**NSLPP MEETING HELD ON 13/09/23****Attachments:**

**ADDRESS/WARD:** Adjacent to 306 Military Road, Cremorne**APPLICATION No:** DA 102/23**PROPOSAL:** Installation and operation of a freestanding advertisement structure for the purposes of Council communication and third-party advertising**PLANS REF:**

**OWNER:** North Sydney Council is the registered owner of public road reserves within the North Sydney LGA**APPLICANT:** JCDecaux Australia Trading Pty Ltd**AUTHOR:** Annelize Kaalsen of AK Planning**DATE OF REPORT:** 10 July 2023**DATE LODGED:** 28 March 2023**AMENDED:** 28 August 2023**RECOMMENDATION:** Approval

**Figure 4: Footpath width**

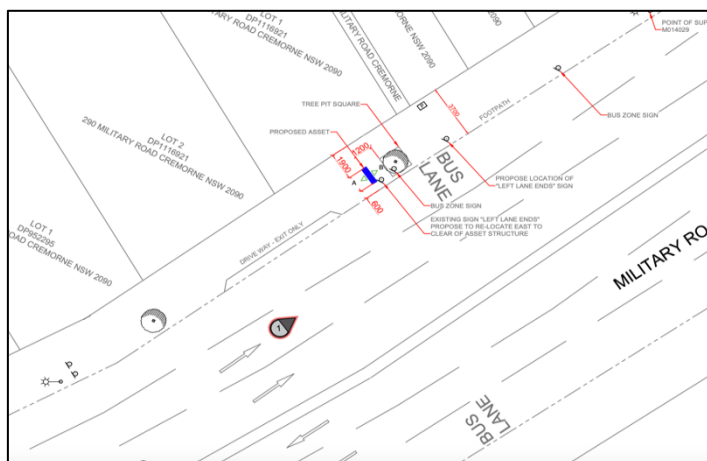
The panel does have the potential of creating a pinch point in the footpath, particularly during peak pedestrian periods. The proposed advertising panel reduces the footpath width to 1.9m – see **Figure 5**. Provision P16 of Section 9.11 of the NSDCP 2013 only requires a minimum unobstructed footpath width of 1.5m for freestanding advertising panels.

As such the remaining footpath width is in accordance with Councils control.

**Figure 5: Perspective of JCDecaux logo**

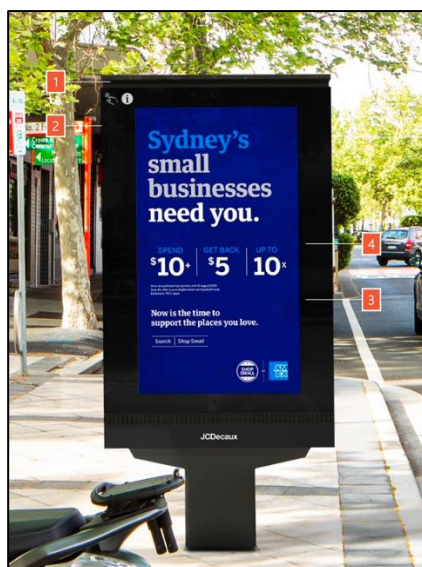
The JCDecaux logo at the bottom of the advertising panel is measured at 200mm x 40mm totalling 0.008sqm, complying with Clause 3.18 – refer to **Figure 5**.
